Memorandum

Re: Mixed Use Development at 321 Commercial Street; Level III Site Plan/Subdivision, J B Brown & Sons Applicant.

Project #: 2012-615 **CBL:** 40-E-3

Meeting Date: November 13, 2012

Plan above is from the draft Access Easement Agreement

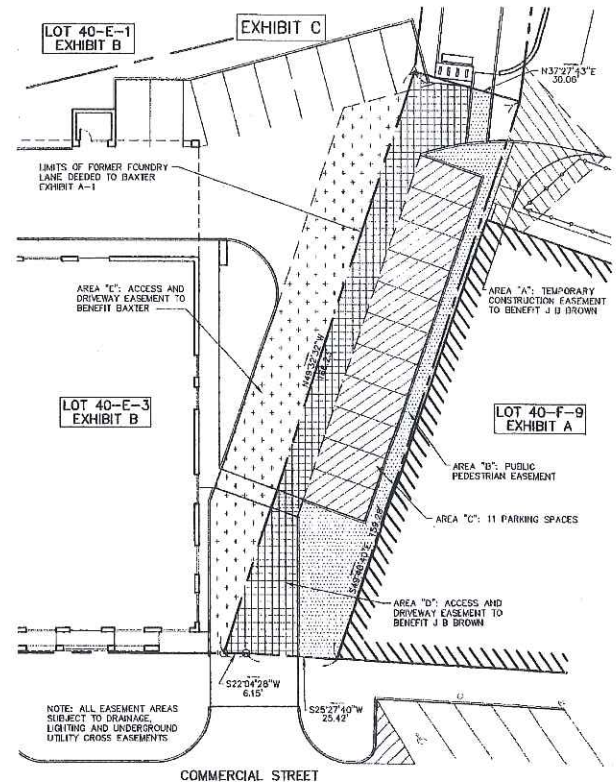
Staff have raised a number of concerns:

- The Historic Preservation Board “*Regarding Foundry Lane, Board members noted that its treatment at the top of the block, done as part of an earlier project, was very successful in that it preserved the memory of the historic alleyway and created an attractive pedestrian corridor. They felt it was important that this treatment continue on the lower portion of Foundry Lane to the extent possible.*” (Attachment 8)

- The existing four street trees (shown on Attachment Plans 2 and 4) are replaced with two trees in small grates and this appears to be an opportunity for some larger scale landscape treatment that is consistent with the historic context and meets stormwater management and site landscaping objectives;

- DPS has commented: *A pedestrian easement is shown on the south side of the former Foundry Lane. A sidewalk is now proposed on the north side of the former Foundry Lane. Will a new easement be necessary? The discontinuance does not call for a Pedestrian Easement. Is there a recorded document which defines it as a Pedestrian Easement?*

- The Transportation reviewer comments: *The 11 parking spaces on the former Foundry Lane do not appear to meet City dimensional standards. A waiver will be required. I would also note that there is general concern about pedestrian accessibility in this area and modifications to the plan may be necessary* (Attachment 7).

Staff suggest that the layout and design of this area be reconsidered and the pedestrian easement issue be clarified.
